RENESAS TECHNICAL UPDATE

Product Category	MPU/MCU		Document No.	TN-RL*-A073A/E	Rev.	1.00
Title	Precaution of using SNOOZE mode		Information Category	Technical Notification		
Applicable Product	RL78/I1D R5F117xx	Lot No.	Reference Document	RL78/I1D User's Manual: Hardware Rev. 2.10 R01UH0474EJ0210 (Jan. 2016)		
		All lot

Figure 23 - 8 When the Interrupt Request Signal is not Generated in the SNOOZE Mode

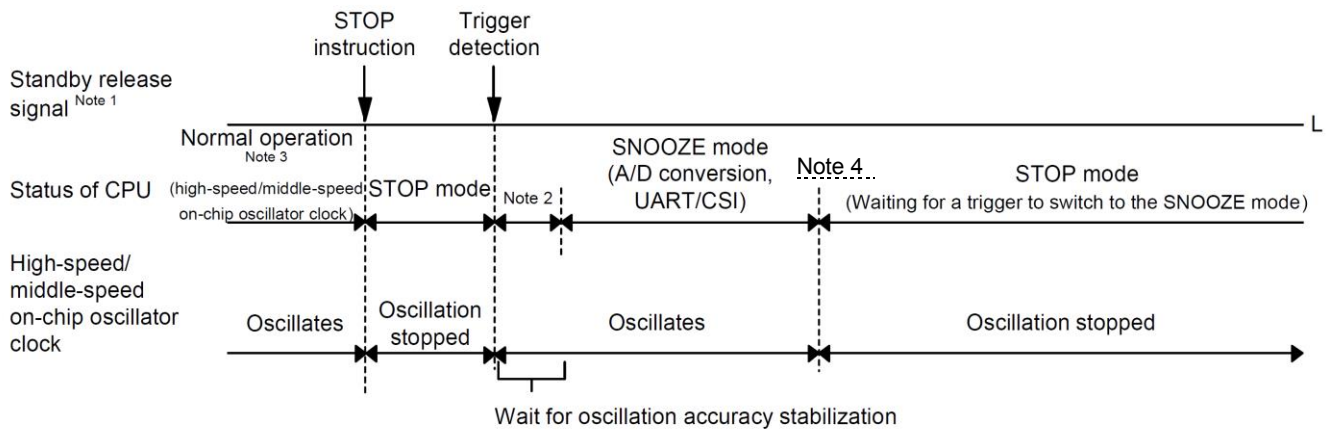
1. Addition of note when an interrupt Request Signal is Generated immediately after SNOOZE Mode transitions to STOP mode. To add a note 4 to timing chart in "(3) Timing diagram when the interrupt request signal is not generated in the SNOOZE mode" on page 724 section 23, Standby function in the User's manual.

- Note 1.** For details of the standby release signal, see **Figure 21 - 1**.
- Note 2.** Transition time from STOP mode to SNOOZE mode
- Note 3.** Enable the SNOOZE mode (AWC = 1 or SWC = 1) immediately before switching to the STOP mode.
- Note 4.** If a standby release signal is generated in response to an interrupt from a peripheral function which is not set to operate in the SNOOZE mode during a transition of state from SNOOZE mode to STOP mode, the high-speed on-chip oscillator clock may run slowly for up to 15µs from when the CPU starts to operate. If the clock frequency accuracy specified in the electrical characteristics is required immediately after release from standby, wait for the number of cycles at the actual CPU clock frequency that is equivalent to 15µs.
